SUBJECT: OCONEE NUCLEAR STATION (ONS) DRAFT UPDATED FINAL  
SAFETY ANALYSIS REPORT (UFSAR) SUPPLEMENT

## **UFSAR Supplement**

**Draft  
February 2000**

## **Changes to Chapters 3, 4, 5, 6, and 9**

Appendix 16.6-2  
Figure 1  
Units 1, 2, and 3

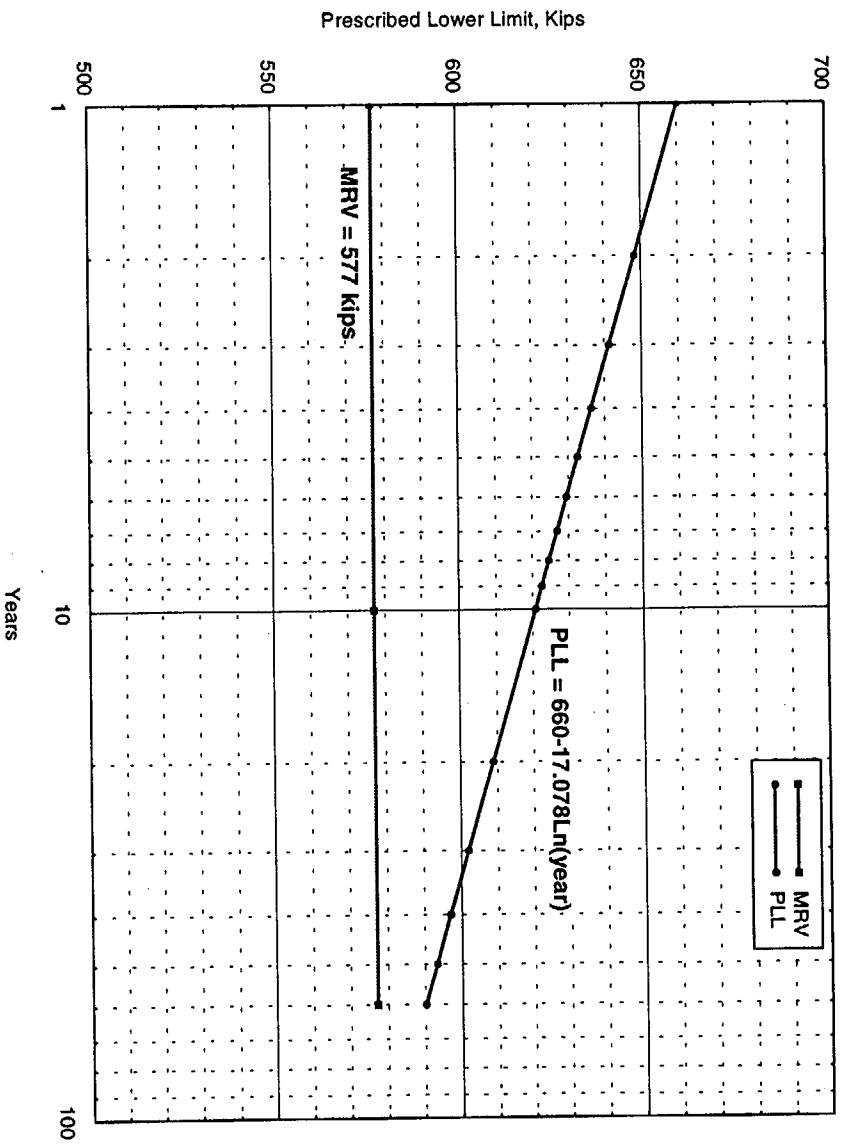
*Revise Figures 1, 2, and 3 of SLC 16.6.2 as follows:*

Estimated 60 Year Prescribed Lower Limit  
Dome Tendons

Appendix 16.6-2  
Figure 3  
Units 1, 2, and 3

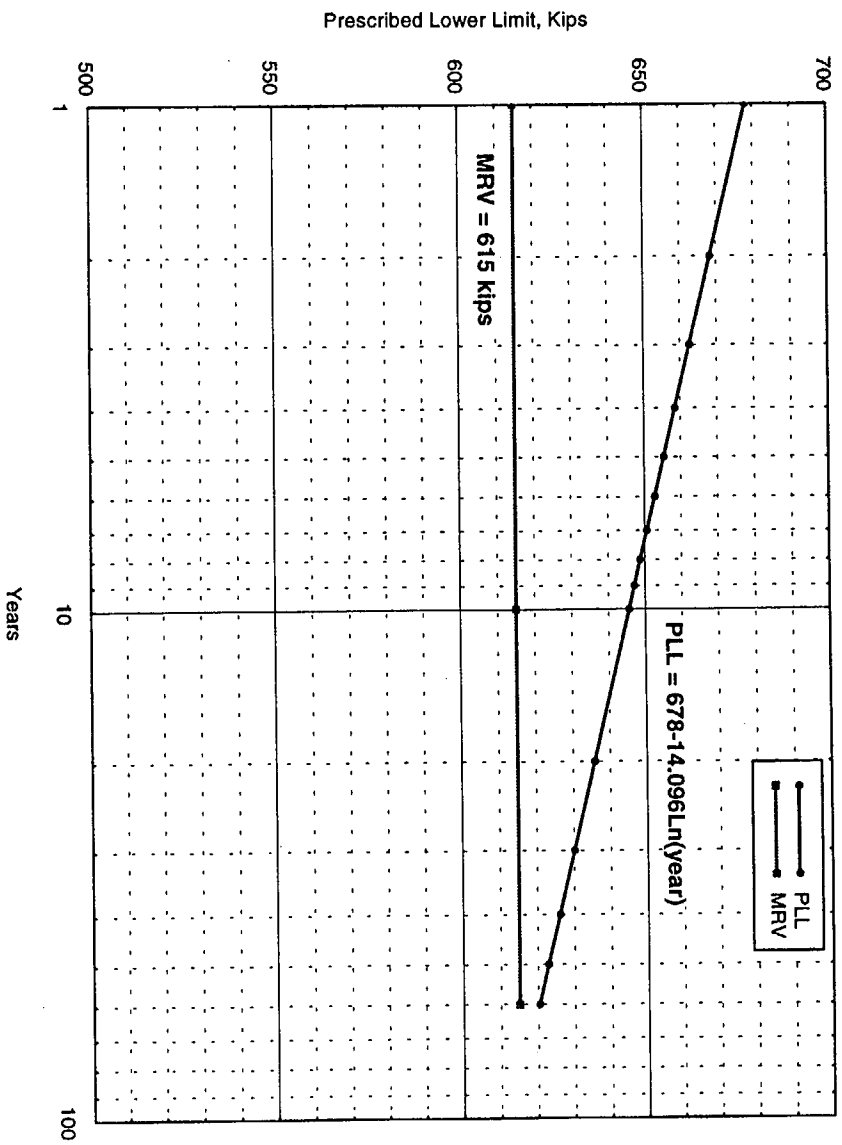
Estimated 60 Year Prescribed Lower Limit  
Vertical Tendons
